# UNITED STATES PATENT AND TRADEMARK OFFICE

10/586,572

<b>Office Action Summary</b>	<b>Application No.</b>	<b>Applicant(s)</b>	
	10/586,572	BJORNSSON ET AL.	
	<b>Examiner</b>	<b>Art Unit</b>	
	Tho v. Duong	3744

Figure A: The modified figure corresponds to figure 4 with limitation shown..

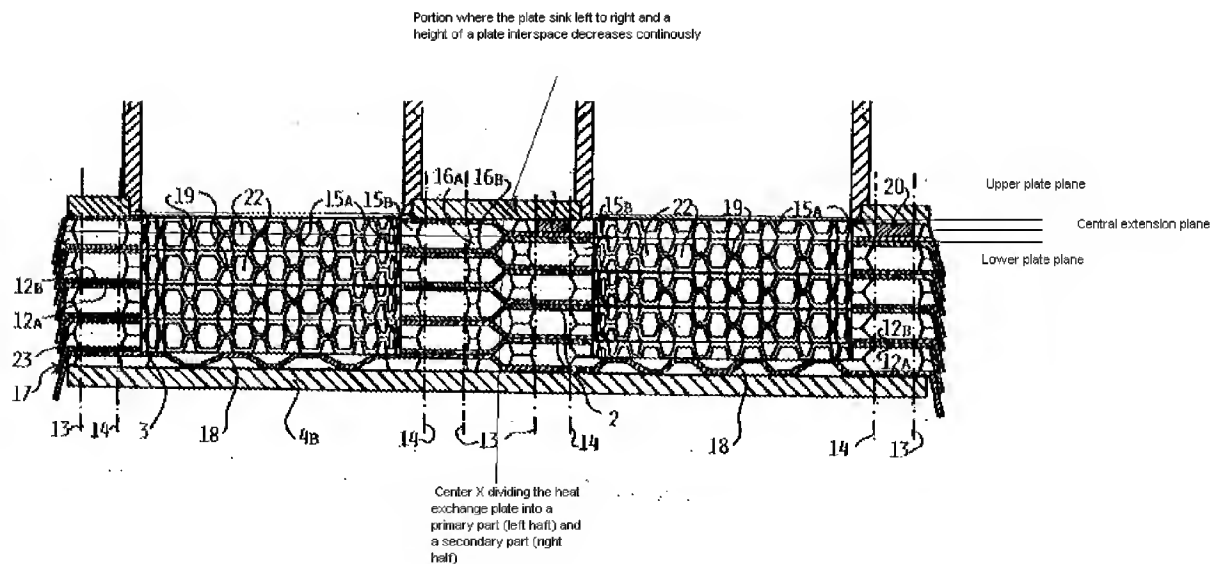
Claims 27-52 are rejected under 35 U.S.C. 102(b) as anticipated by or, in the alternative, under 35 U.S.C. 103(a) as obvious over Bergqvist et al. (US 4,987,955). Bergqvist discloses (figures 1-4 and figure A as see bellow) a plate package for a plate heat exchanger including at least two identical heat exchanger plates having a plate interspace therebetween, wherein the heat exchanger plate extends between a primary edge zone and a secondary edge zone in parallel with a central extension plane, an upper plate plane and a lower plate plane, wherein the central extension plane includes a center axis dividing the heat exchanger plate into a primary part and a secondary part, the heat exchanger plate comprising a first end area, a second end area, a central heat transfer area (9), which extends between the primary edge zone and the secondary edge zone from the first area to the second end area; a primary porthole (11a) and a secondary porthole (11b), which extend through the heat exchanger plate in the first end area and each of which is surrounded by a respective adjoining edge area, wherein the primary porthole (11a) is located on the primary part and the secondary porthole (11b) is located on the secondary part, a

distribution area which extends on the first end area and has a base surface extending from the primary porthole (11a) to the central heat transfer area, wherein the base surface is located at an upper level in the proximity of the upper plate plane in the proximity of the edge area of the primary porthole and sinks successively to a lower level in the proximity of the lower plate plane in the proximity of the secondary edge zone; the base surface sinks continuously along a border to the central heat transfer area from the upper level to the lower level and from the proximity of the primary edge zone to the proximity of the secondary edge zone; the distribution area includes a number of projections and depressions (15), and substantially each projection extends in a respective direction running from the primary port hole towards the central heat transfer area; wherein the projection (15) has a length which is substantially shorter than the distance from the primary porthole to the central heat transfer surface area along the direction of the projection. Regarding claim 35, wherein substantially each depression (depression formed between two projections 15, figure 2) extends substantially perpendicular to the direction of an adjacent projection, wherein the direction of the projection is considered to be radial direction to center of the port hole. Regarding claims 36, 37 and 39, Bergqvist discloses (column 3, lines 45-60) the heat exchanger plate is symmetrical with regard to the center axis so that substantially each depression has a shape and a position corresponding to a shape and a position of a projection on the other side of the center axis, and each depression is designed to abut a projection of an adjacent turned heat exchanger plate in the plate package. Regarding claim 28, the limitation of "compression-molding" is not germane to the issue of the patentability of the device itself. "Even though product-by-process claims are limited by and defined by the process, determination of patentability is based on the product itself. The patentability of a product does not depend on its method of production. If the product in the product-by-process claim is the same as or obvious from a product of

Regarding claims 38 and 49, applicant is reminded that the examiner must interpret the limitation as broadly as it reasonably allows, in which Bergqvist discloses (figure 2) each projection (15) and depression (between the projections) having two long sides and two ends wherein one of the ends of the projections on the secondary part extends to one of the long side of a depression and one of the ends of the depression on the primary part extends to one of the long sides of a projection.
